**SERVICING DESIGN BRIEF
AND
STORMWATER MANAGEMENT
REPORT**

1420 EARL ARMSTRONG ROAD

TOWN SQUARE CENTRE

**SITE PLAN APPLICATION
FILE No. DO7-12-14-0067**

PLAN OF SURVEY OF CONGRESSION 2 (RIDEAU FRONT) CITY OF OTTAWA
 Surveyed by Arnis, O'Sullivan, Vollebæk Ltd.

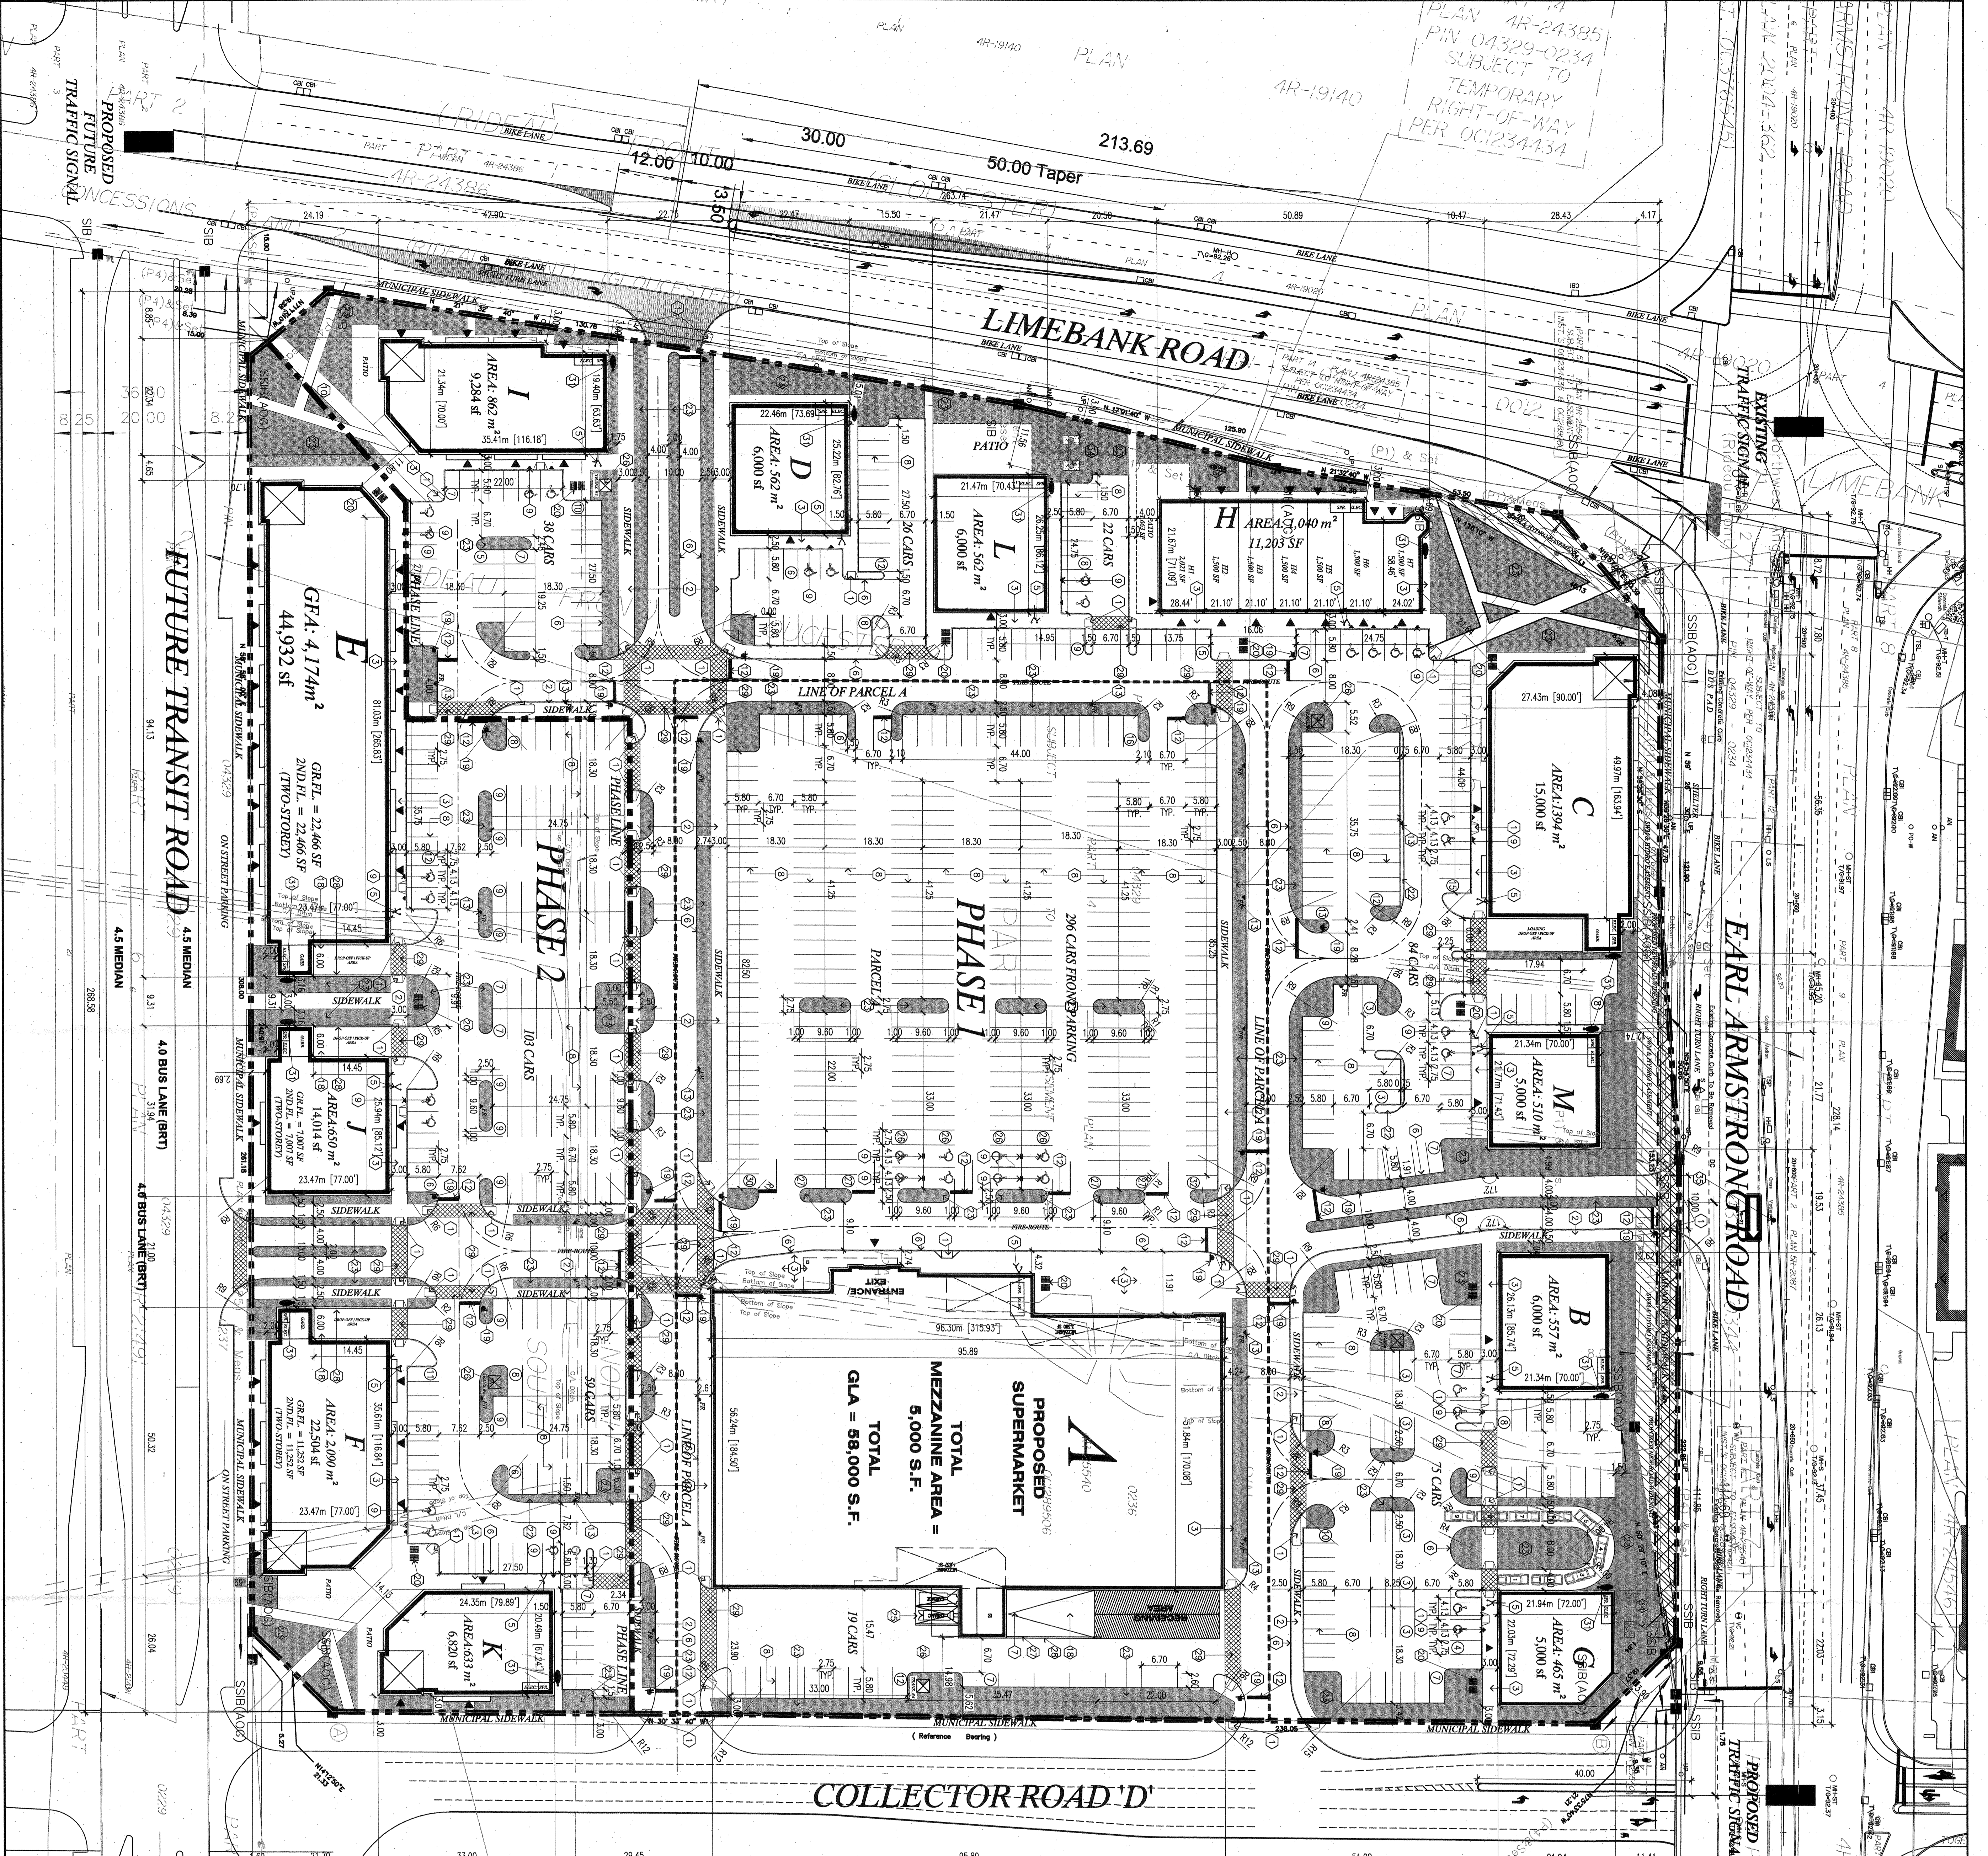
92. See comment on Dwg 4 of 8 regarding identifying which drawing to be used for off-site ditch construction detail

Response: *Noted*
